WESTMINSTER PARK SUBDIVISION

Engineering Comments: FINAL PLAT COMMENTS (should be addressed prior to submitting the FINAL PLAT for review and/or signature by the City Engineer):

APPLICATION NUMBER 5 DATE August 3, 2017

DETAIL SITE PLAN

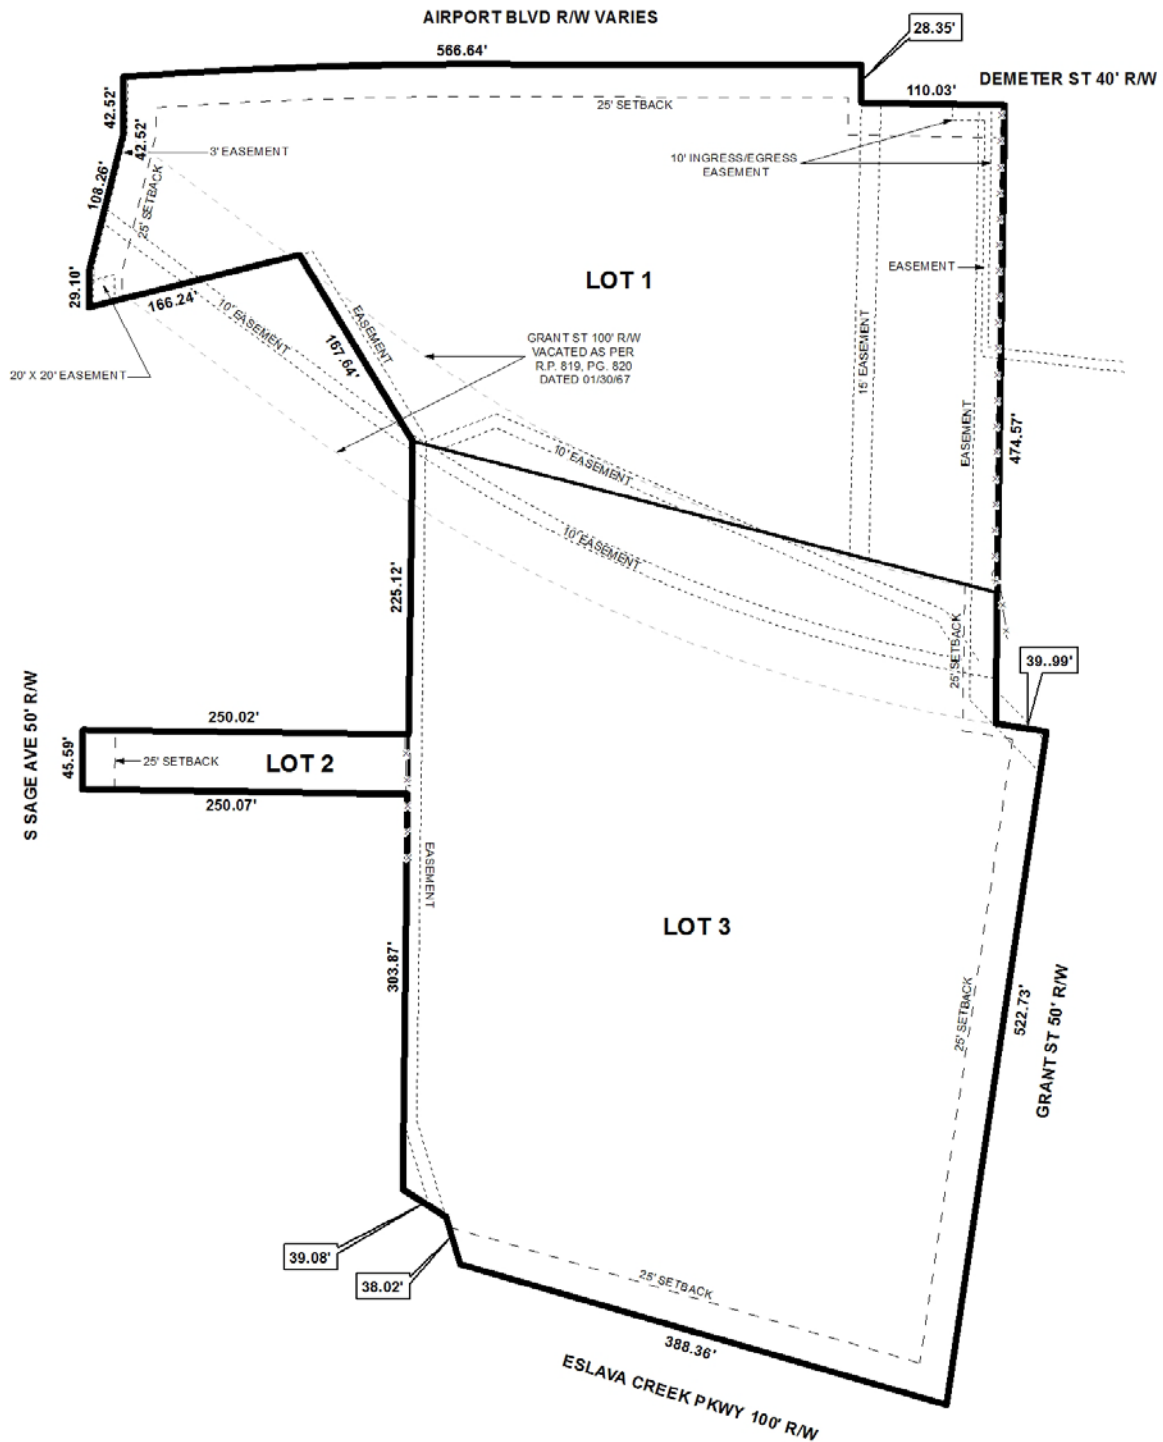
- B. Dedicate the corner radius (25' minimum or as approved by the City Engineer and Traffic Engineer) at the southeast corner of LOT 3.
- C. Revise the signature block from "CITY OF MOBILE ENGINEERING" to "CITY ENGINEER".

Being that the subject site has frontage at the corner of Airport Boulevard and South Sage Avenue and the corner of Grant Street and Eslava Creek Parkway, the applicant must ensure that the property lines at these intersections provide a compliant curb radius. The Final Plat, if approved, should be revised to illustrate a dimensioned curb radius in compliance with Section V.D.6. of the Subdivision Regulations for each intersection.

There are two 10' existing waterline easements that bisect the property between the proposed Lots 1 and 3. Additionally, there is an existing 10' permanent water and sewer easement located along the Western perimeter of the proposed Lot 3. A 10' ingress/egress and sanitary sewer easement, a drainage easement, and an additional permanent sewer easement are all located at the Northeastern corner of the proposed Lot 1. And, a 15' easement for storm and sanitary sewer lines transverses the proposed Lot 1 near the Eastern perimeter of the subject site. The Northwestern corner of the proposed Lot 1 has a 3' strip easement, as well as a 20'x20' easement, granted to Bellsouth Telecommunications, Incorporated. The waterline, sewer, drainage, ingress/egress, storm and sanitary sewer lines, and telecommunications easements should remain on the Final Plat, if approved, as well as a providing a note stating that there should be no structures erected within any easements.

As a means of access management, a note should be placed on the Final Plat stating that Lots 1 and 2 are limited to the existing curb-cuts to Airport Boulevard and South Sage Avenue, and that Lot 3 is limited to one curb-cut each to Grant Street and Eslava Creek Parkway, with any changes in the size, location and design to be approved by Traffic Engineering and conform to AASHTO standards. Additionally, Lot 1 will be denied access to Demeter Street.

- 3) Retention of the 40' wide right-of-way width along Demeter Street;
- 4) Retention of the 100' wide right-of-way width along Eslava Creek Parkway;
- 5) Dedication of a corner radius at the intersections of Airport Boulevard and South Sage Avenue and Grant Street and Eslava Creek Parkway in compliance with Section V.D.6. of the Subdivision Regulations;

- 8) Placement of a note stating that there should be no structures erected within any easements;
- 9) Retention of the note and graphic regarding the Grant Street vacation;

- 10) Retention of the lot size information in both square feet and in acres;
- 11) Placement of a note on the Final Plat stating that Lots 1 and 2 are limited to the existing curb-cuts to Airport Boulevard and South Sage Avenue, and that Lot 3 is limited to one curb-cut each to Grant Street and Eslava Creek Parkway, with any changes in the size, location and design to be approved by Traffic Engineering and conform to AASHTO standards;

- 12) Placement of a note on the Final Plat stating that Lot 1 is denied access to Demeter Street;
- 13) Compliance with Engineering comments (FINAL PLAT COMMENTS *(should be addressed prior to submitting the FINAL PLAT for review and/or signature by the City Engineer)*: A. Provide all of the required information on the SUBDIVISION PLAT (i.e. signature blocks, signatures, certification statements, written legal description, required notes, legend, scale, bearings and distances) that is required by the current Alabama State Board of Licensure for Professional Engineers and Land Surveyors. B. Dedicate the corner radius (25' minimum or as approved by the City Engineer and Traffic Engineer) at the southeast corner of LOT 3. C. Revise the signature block from "CITY OF MOBILE ENGINEERING" to "CITY ENGINEER". D. Provide the Surveyor's, Owner's (notarized), Planning Commission, and Traffic Engineering signatures. E. Add a note to the SUBDIVISION PLAT stating that a Land Disturbance permit will be required for any land disturbing activity in accordance with Mobile City Code, Chapter 17, Storm Water Management and Flood Control); the City of
